1930 Constant Avenue
Lawrence, KS 66047-3724
September 28, 2007

I was asked to comment on the wastewater treatment expansion plans for the City of Severy. I noticed that the area of the proposed lagoon is situated on silty clay loams. These soils are of fairly low permeability and suitable for the lagoons provided that the soil is compacted or lined. One comment is that there will be a large amount of soil and sediment removed for the installation of the embankment. Where will that sediment be taken from? How will the sediment removal area be renovated to prevent leaching if the topsoil (fairly low permeability) is removed? There was no information provided about the lower sediment/rock composition so I do not know how thick the overlying soil is in terms of potential leaching issues at depth.

Project Title: Municipal Programs Section Revolving Loan Fund Application

RE: City of Severy, Kansas
Wastewater System Improvements
KWPCRF Project No. C20-1724-01

S/2, SW/4, NW/4
S17, T28S, R11E
GREEN WOOD County, Kansas

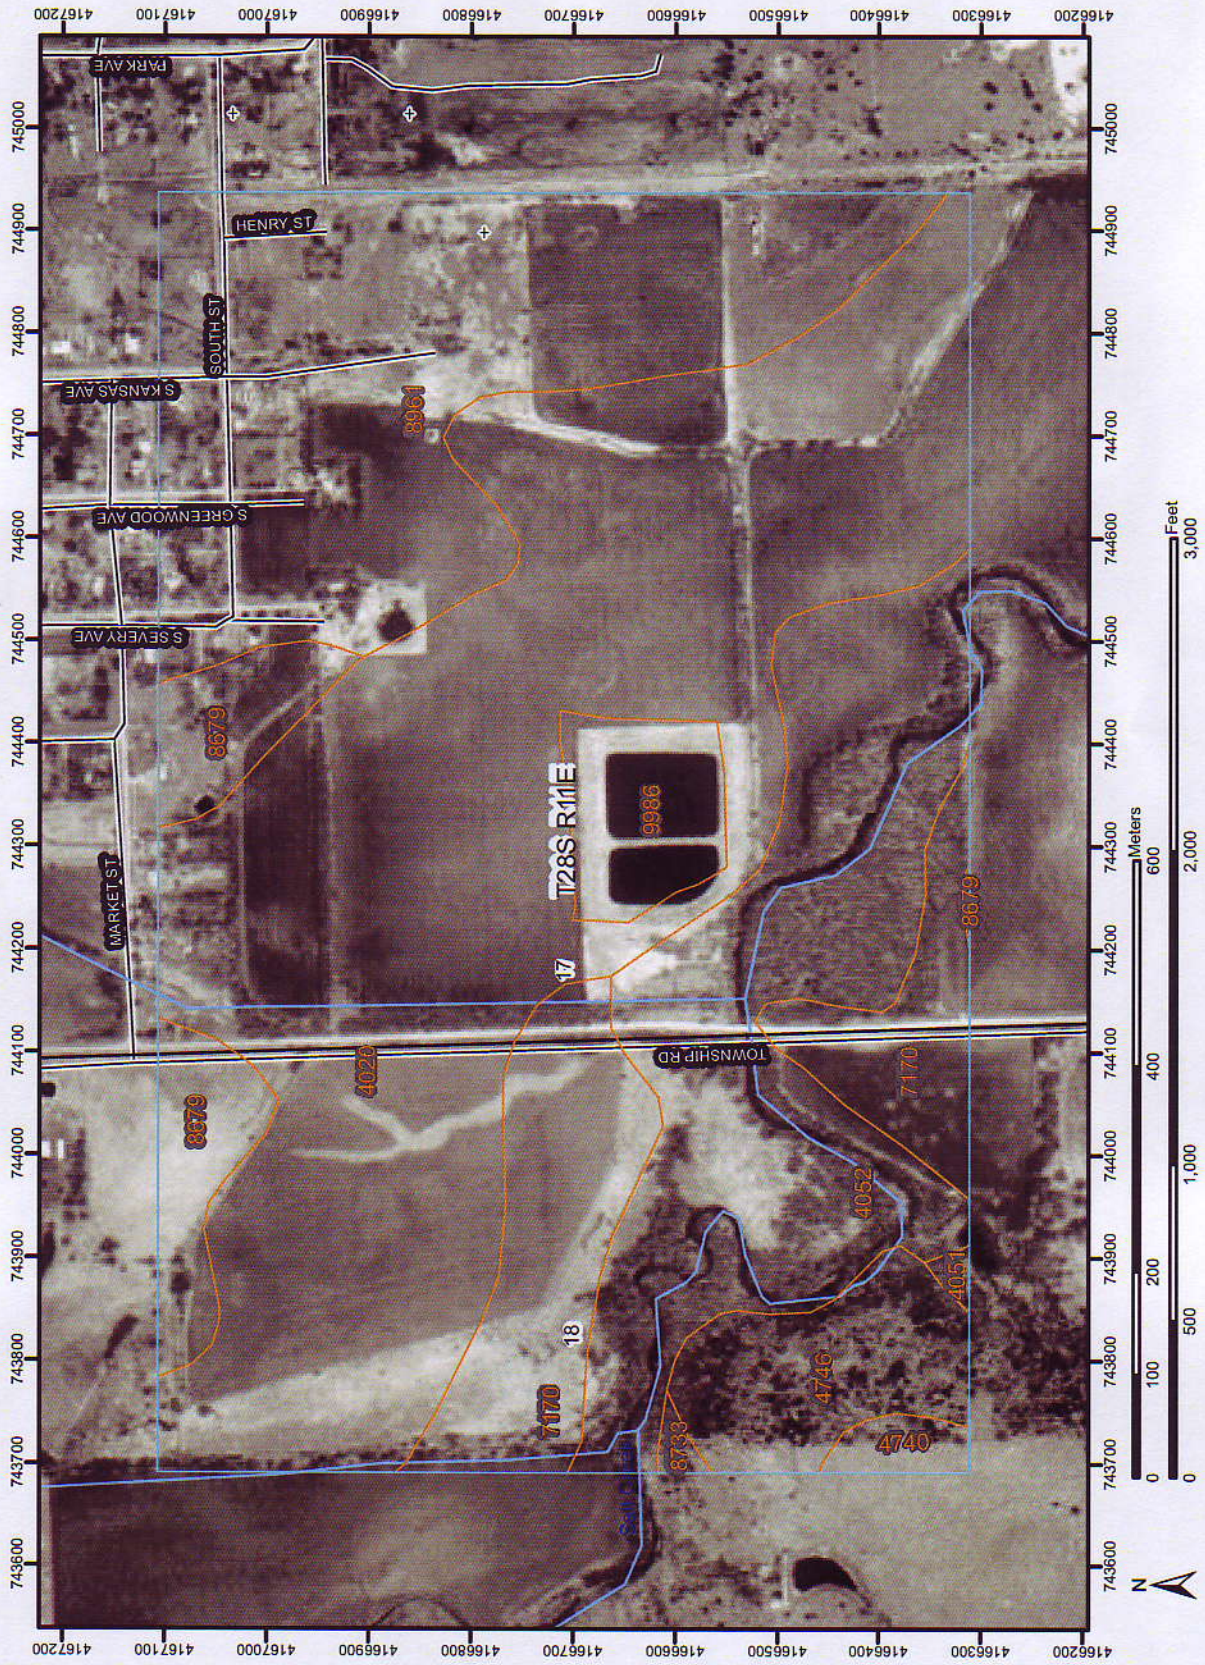
The other observation is that lagoons are located near the stream. I presume that precautions have been taken to prevent flooding either of the lagoon by the stream or overflow from the lagoons to the stream.
